ADDENDUM #2

PROJECT: Thousand Islands Secondary School
HVAC Replacement & Upgrades
PROJ. NO.: 24078
DATE: April 29, 2026

DRAWING:
ELECTRICAL:
SITE PLAN

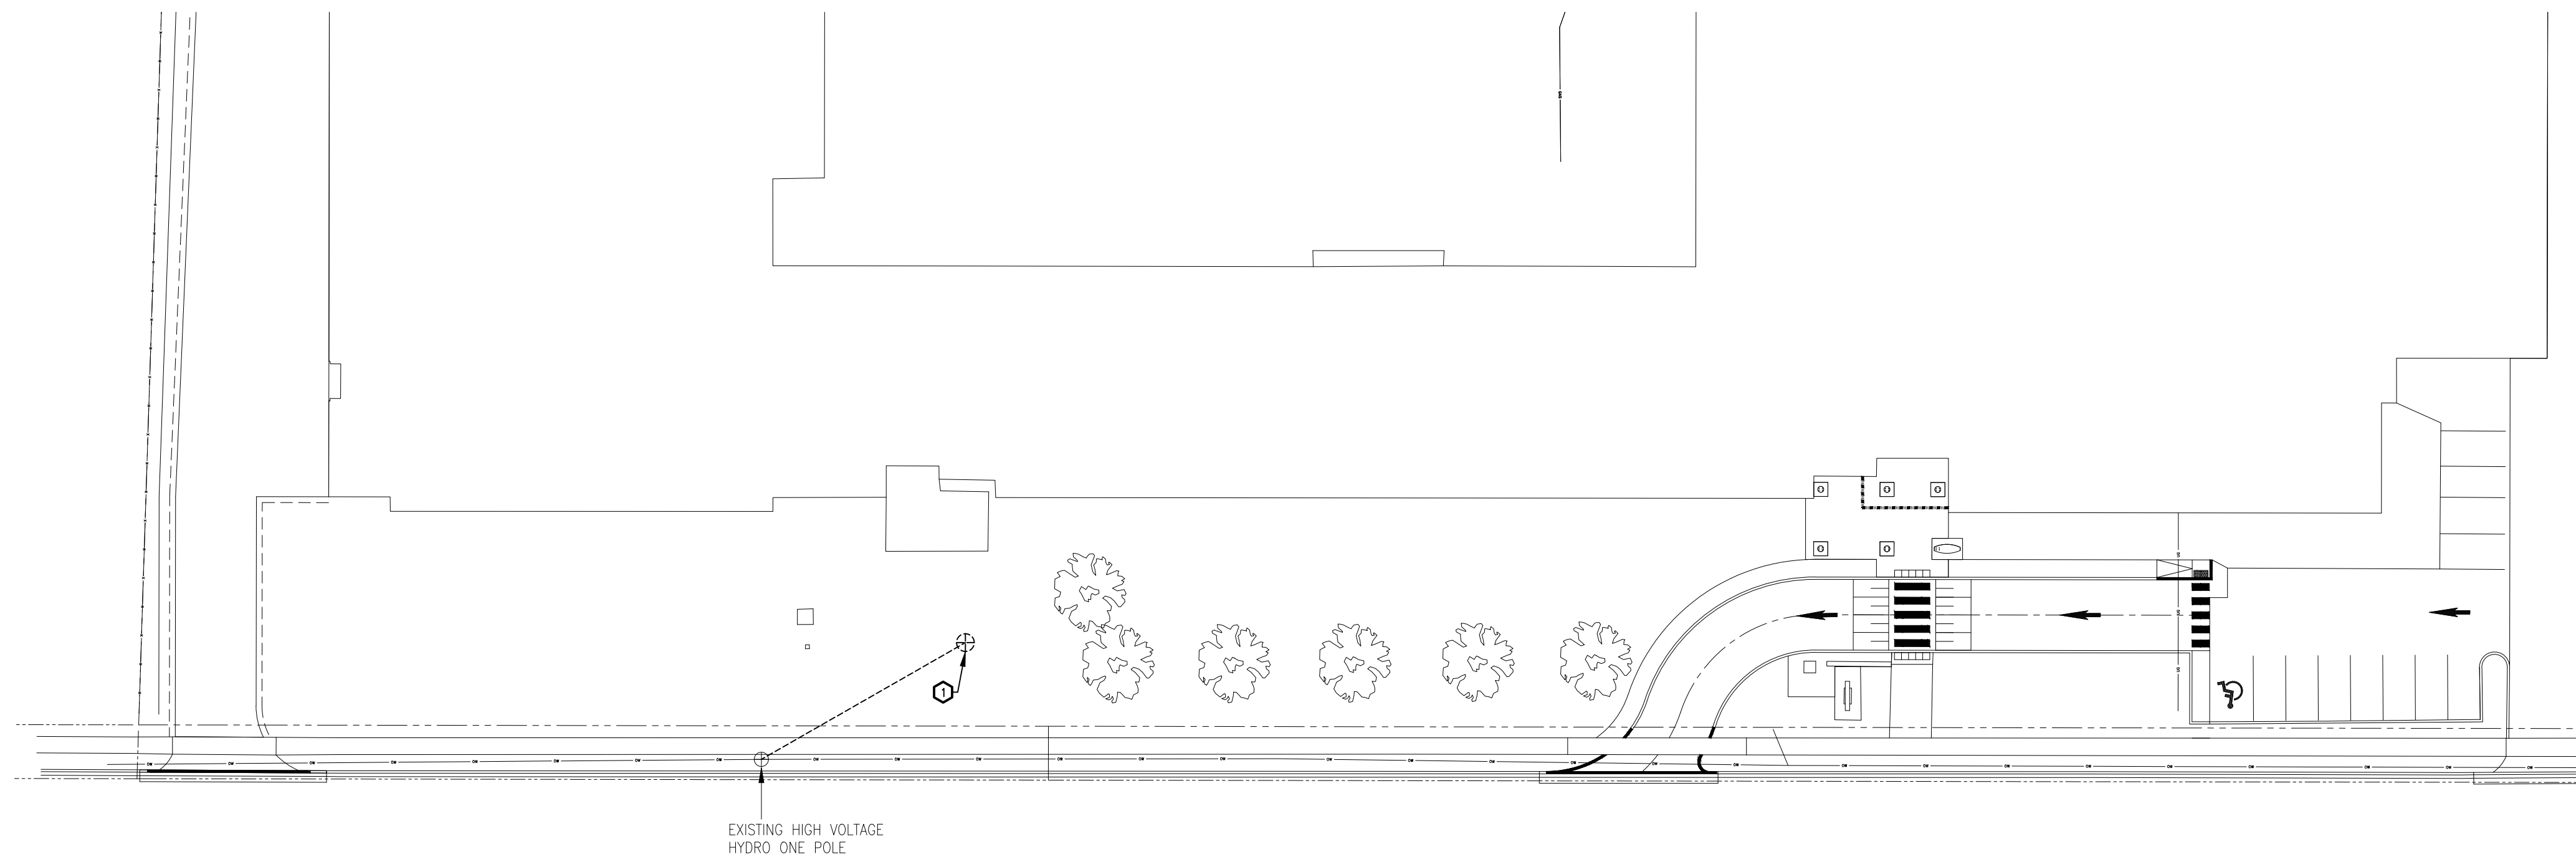
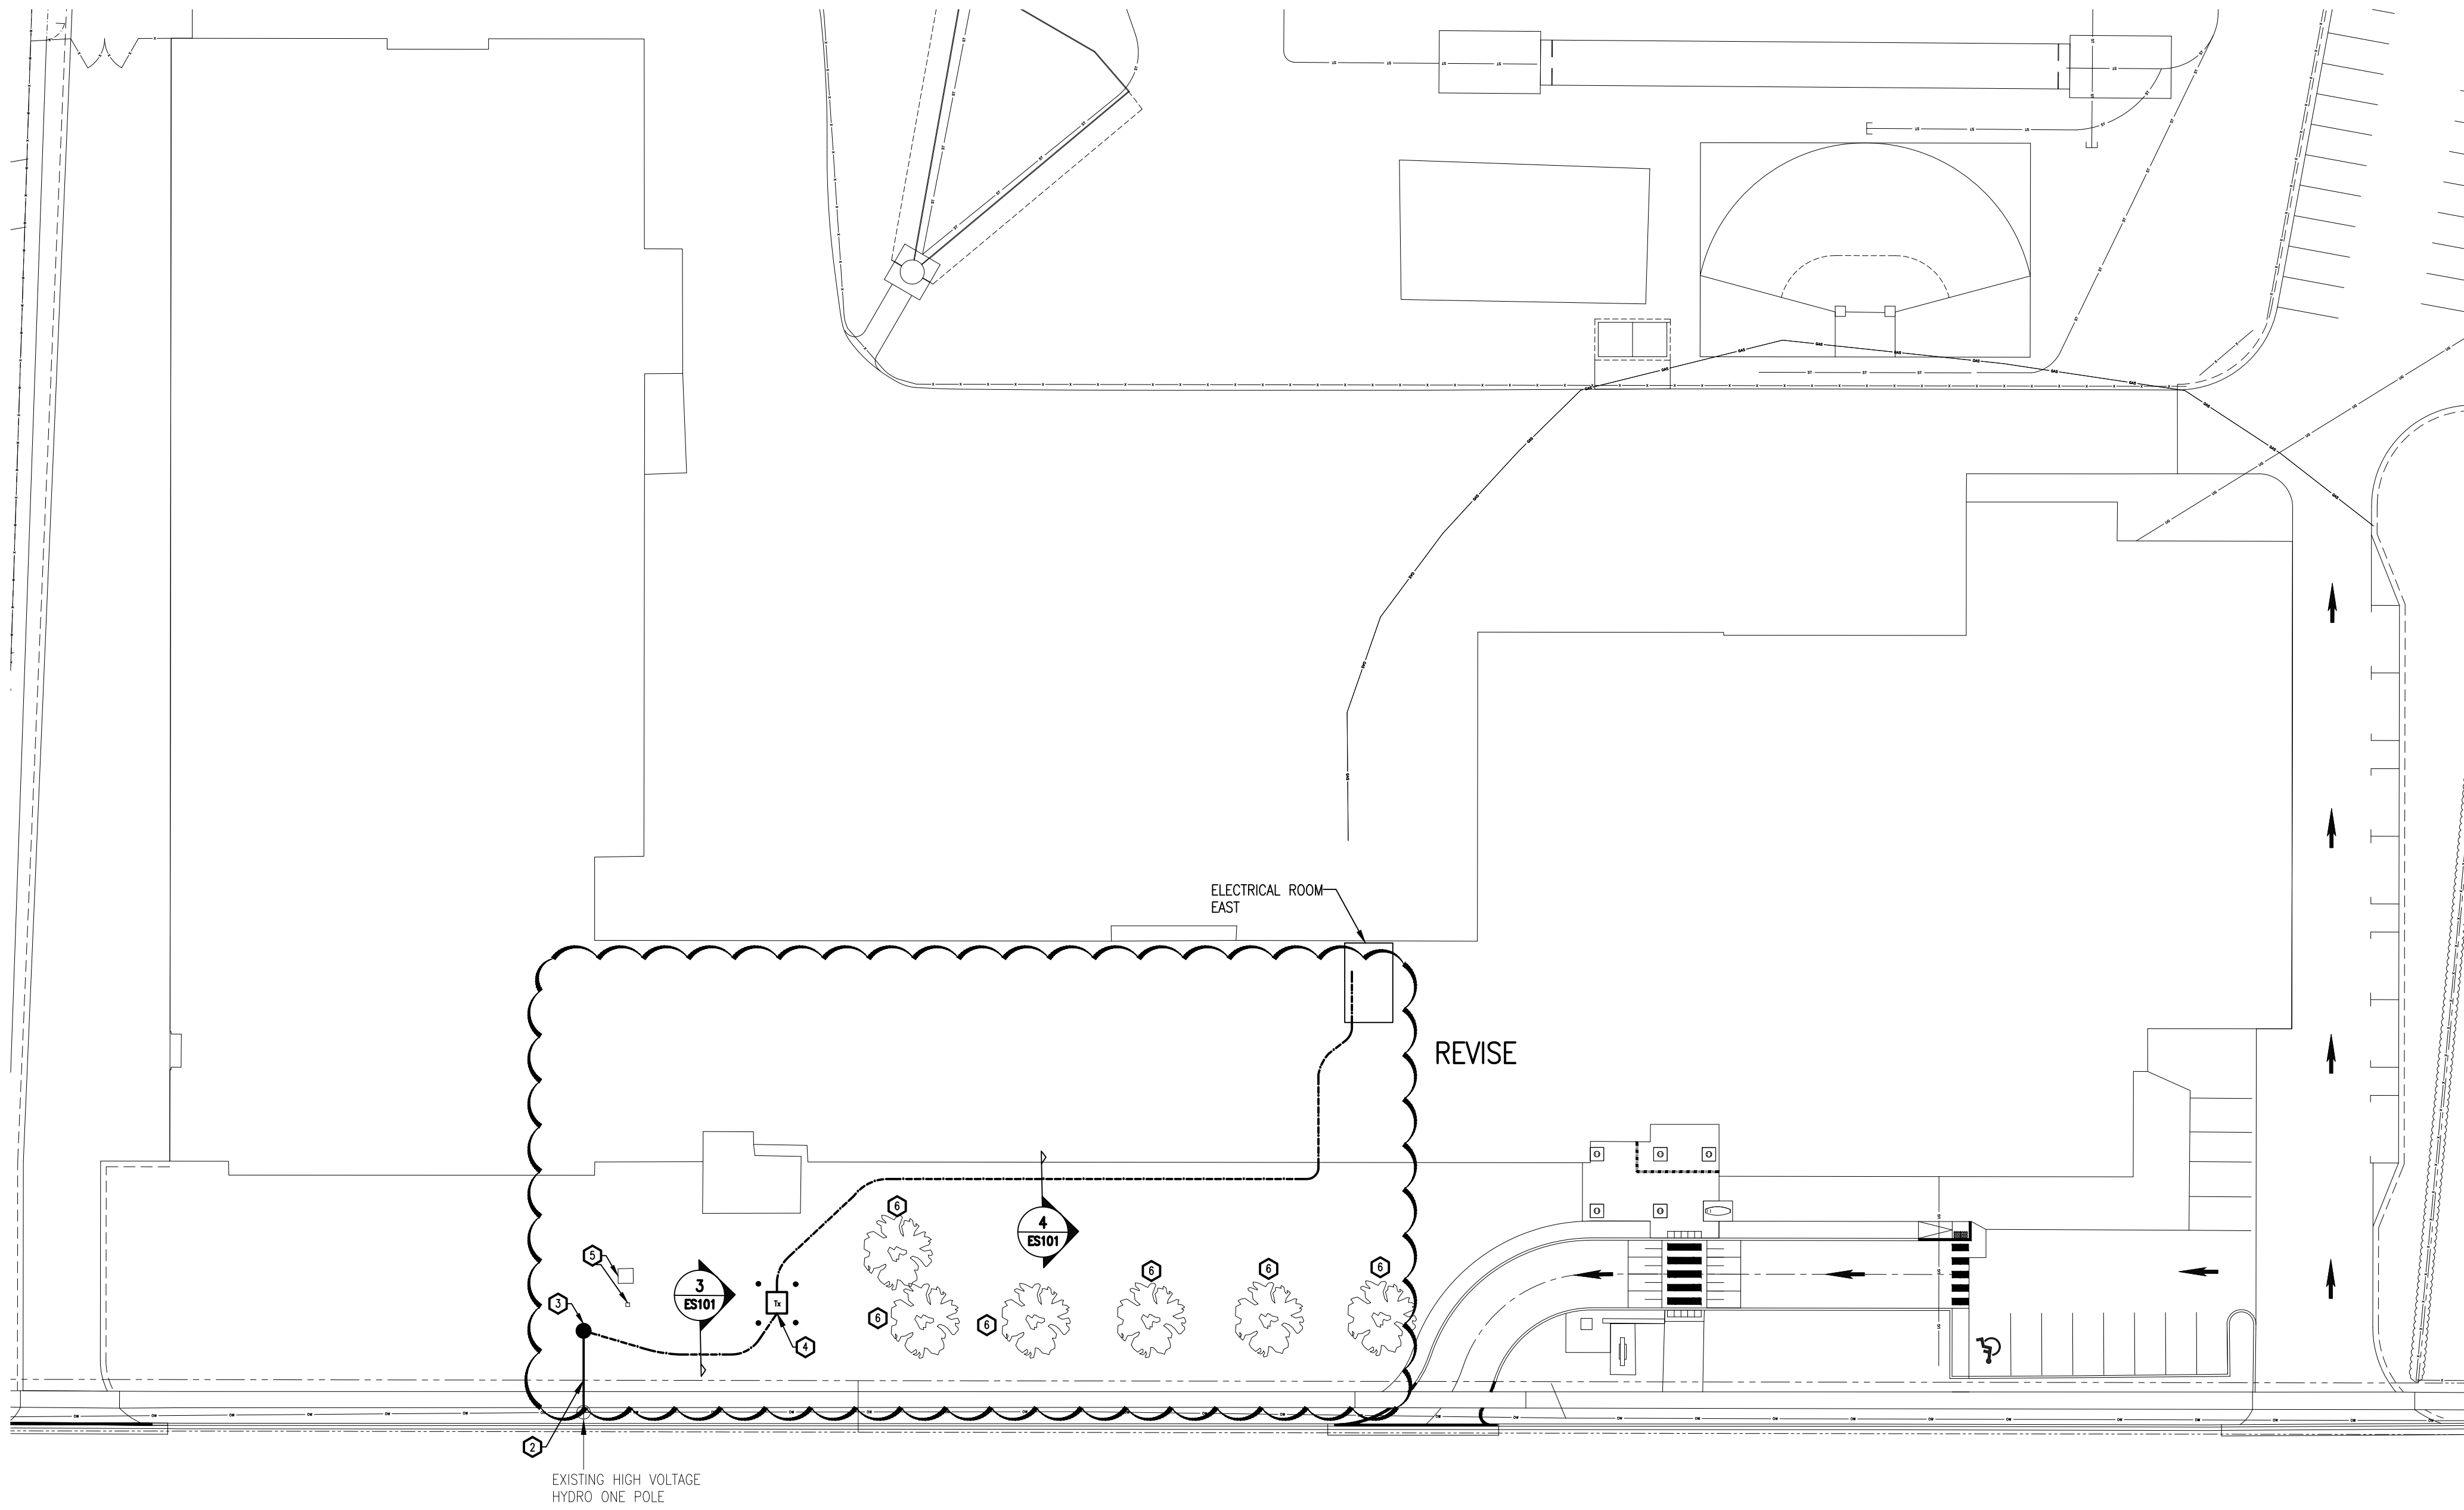
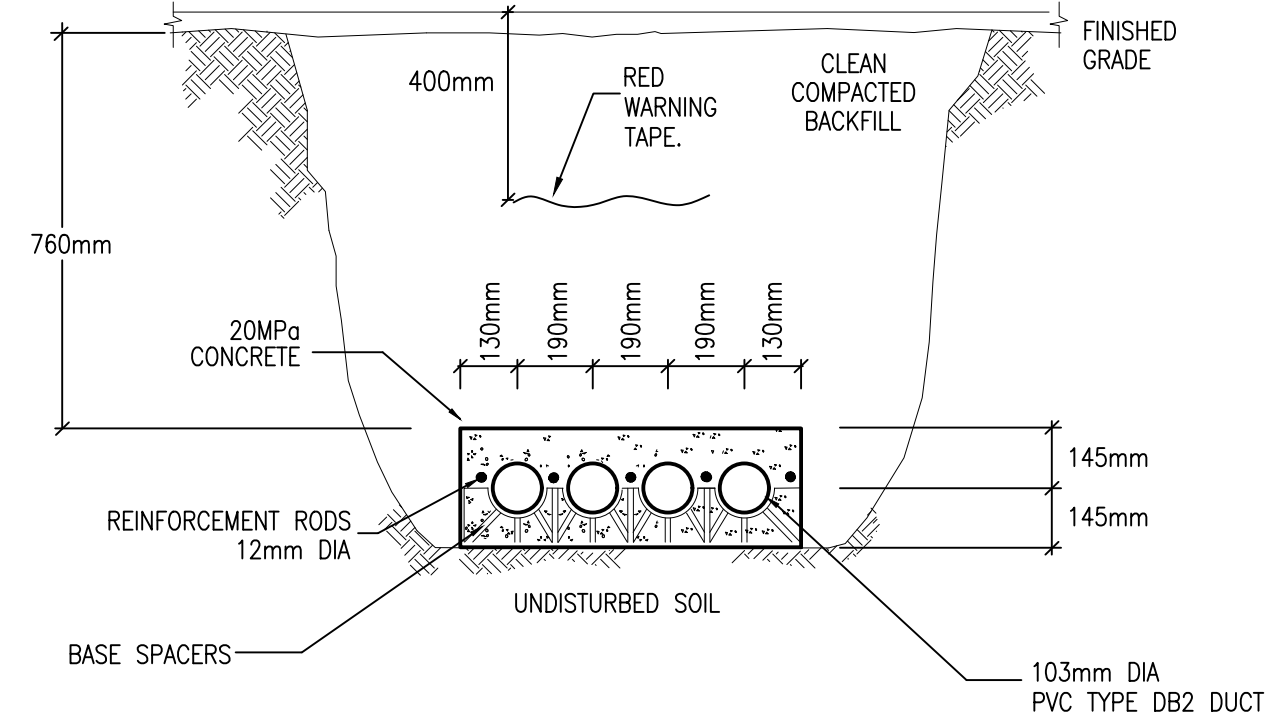
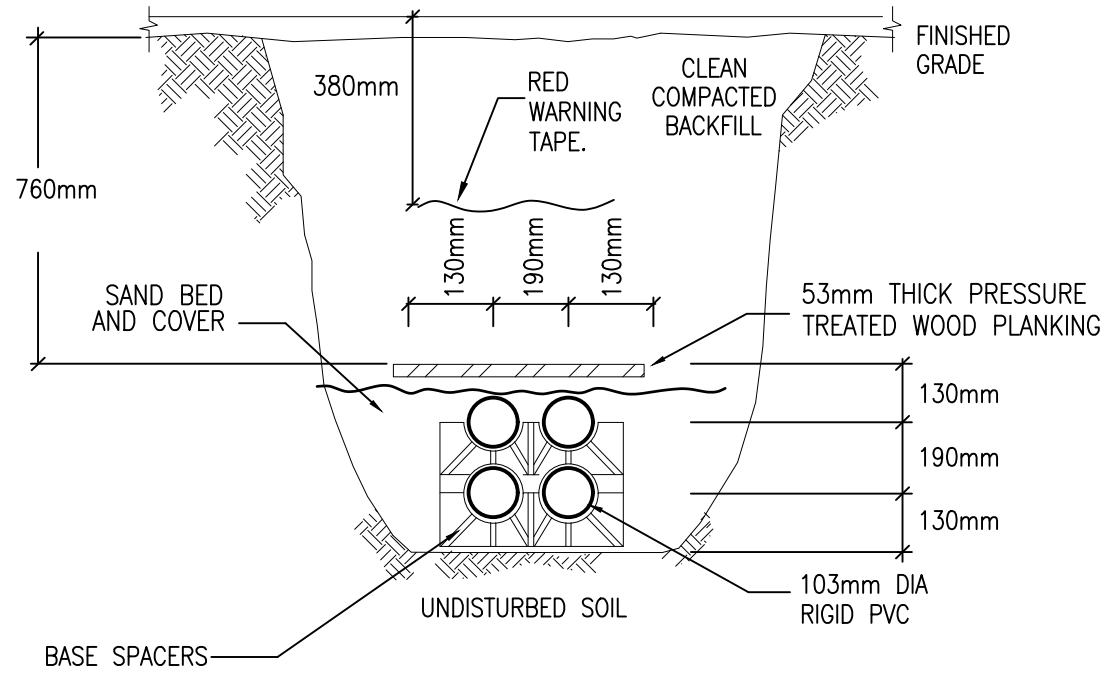
12. Q: Drawings do not show any sidewalk removal and reinstatement at area of electrical trench from new pole to new transformer. Will the sidewalk need to be cut, removed and replaced? There are also a light and a sign structure in the same area, will these be affected by the trench?
A: Refer to electrical addendum E001.

13. Q: Electrical trench - is detail 3 on drawing ES101 to be followed, or are the specs section 33 65 73 - Part 3 to be followed?
A: Documents to be read together, refer to electrical addendum E001.

- 5 AVOID AND MAINTAIN EXISTING GROUND MOUNTED FLOODLIGHT AND SIGN.
 - 6 AVOID EXISTING TREES AND ROOT BALLS

NOTE: REINSTATE GRASS IN AREA OF NEW TRENCH

NOTES: DIMENSIONS SHALL BE ACCORDING TO OESC D11, DETAIL 4
REINSTATE GRASS IN AREA OF NEW TRENCH
